STAFF REPORT

SPECIAL EXCEPTION AMENDMENT APPLICATION SEA 81-L-057-2

APPLICANT:	McDonald's Corporation	CRD
ZONING:	C-8, HC, CRD	
PARCEL(S):	92-4 ((2)) 3 and 4	
ACREAGE:	1.57 acres	
FAR:	.07	
OPEN SPACE:	26.5%	
PLAN MAP:	Retail use up to .50 FAR	
SE CATEGORY:	Category 6, Approval of fast food restaurants in a Highway Corridor Overlay District	
PROPOSAL:	The applicant proposes to amend SE 81-L-057, previously approved for a fast food restaurant with drive-through, for a new fast food restaurant with drive-through.

REGIONAL DWG. NO: 5075034 PLAN DESCRIPTION: LANDSCAPE PLAN

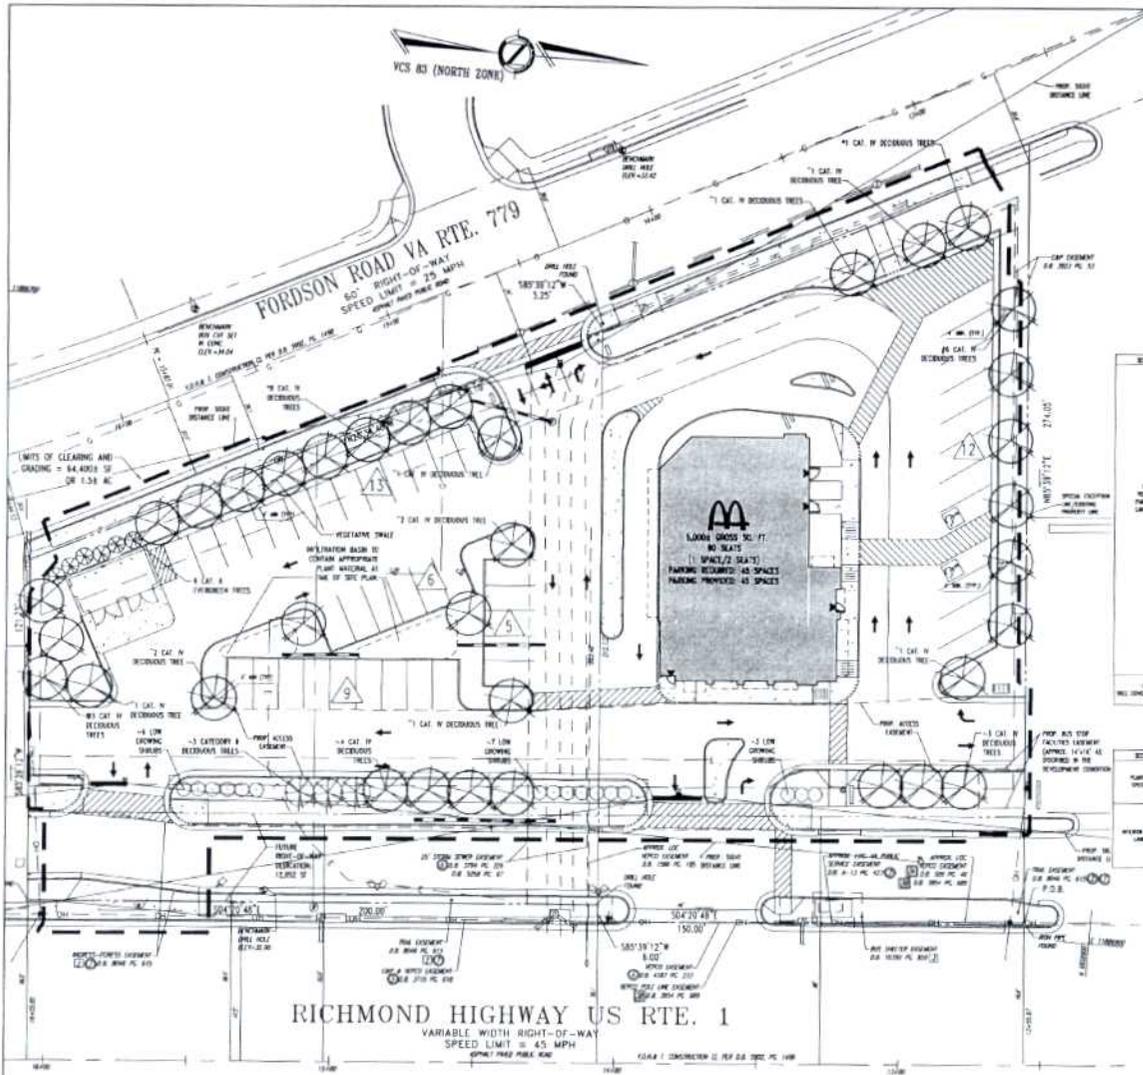
UFMD staff identified issues related to: tree preservation along the northern and southern boundaries of the site; tree plantings within four (4) feet of a barrier; and the 10-year Tree Canopy requirement. As discussed earlier, the applicant proposes to remove and replace the trees along the northern and southern boundaries of the site, as recommended by UFMD. The applicant has also committed to providing the required 10-year Tree Canopy requirement through on-site tree plantings, as noted on the SEA Plat. However, due to the proposed redevelopment of the entire site, the applicant is not able to preserve any trees on site and requests a deviation of the Tree

Since all of the existing vegetation will be removed for the redevelopment of the site, the applicant is unable to meet the required Tree Preservation Target for the development site. The applicant originally proposed to preserve the existing mature trees along the northern and southern boundaries of the site. However, due to the condition of these trees, UFMD staff recommended that the trees be removed and replaced. The applicant has therefore requested a deviation from the Tree Preservation Target. The applicant proposes to meet the 10-year Tree Canopy requirement with the plantings of the new deciduous trees around the periphery of the site and within the parking lot. Therefore, staff supports the requested deviation from the tree preservation target percentage in favor of the proposed landscaping shown on the SEA Plat.

Staff recommends that the Board of Supervisors direct the Director of DPWES to permit a deviation from the tree preservation target percentage in favor of the proposed landscaping shown on the SEA Plat.

Streetscape - Richmond Highway

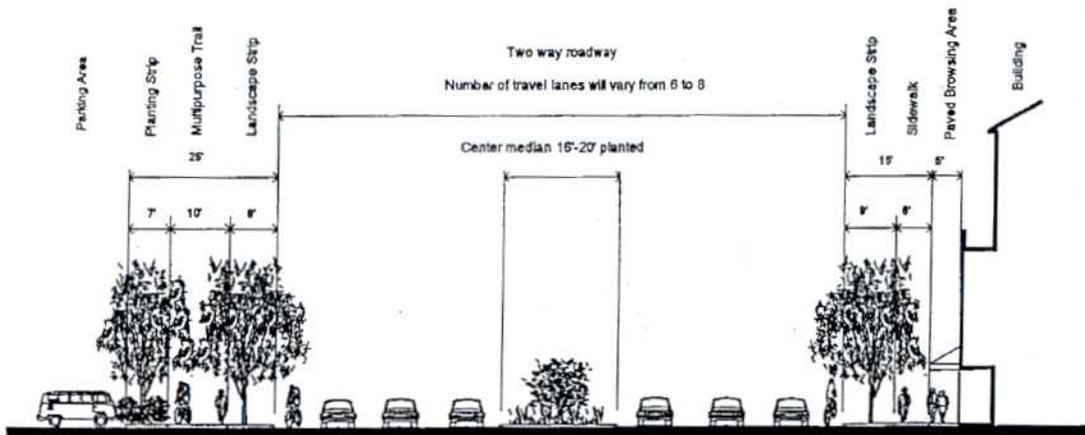
asphalt trail along the Richmond Highway frontage. Approximately half of the proposed trail will be within the ROW along Richmond Highway. Though the recommended streetscape is not provided, the applicant is providing a sizable trail and landscape strip that will accommodate adequate pedestrian activity and landscaping along a small, irregular shaped site. A new five (5) foot wide concrete sidewalk as well as a ten (10) foot wide landscape strip with trees is now proposed along Fordson Road. However, trees cannot be planted along the full length of Fordson Road due to an existing utility easement along the northern portion of the road, which is continued from the northern boundary of the site. Within the constraints of the asymmetrical site, the applicant has provided sufficient landscaping, sidewalks and trails; therefore, staff believes that the provided streetscape is generally in conformance with the Comprehensive Plan's streetscape recommendations and does not object to the applicant's proposed modifications.

Streetscaping The applicant is proposing to keep the existing concrete median in between the service drive and Richmond Highway unchanged and anticipates that this median will serve as a sidewalk to fulfill the Comprehensive Plan recommendations for trail improvements. Staff considers this proposal to be insufficient. The applicant is advised to establish a concrete sidewalk along the median located in between the service drive and the internal driveway. A sidewalk located here would have the ability to connect to potential sidewalks to the north and south of the property and provide sufficient refuge to pedestrians. The approximately 15 foot wide area is wide enough to accommodate a nine foot wide trail and six foot wide planting area with street trees evenly spaced.

Staff recommends approval of the modification of the Richmond Highway Corridor Area Streetscape Elements to that shown on the SEA Plat.
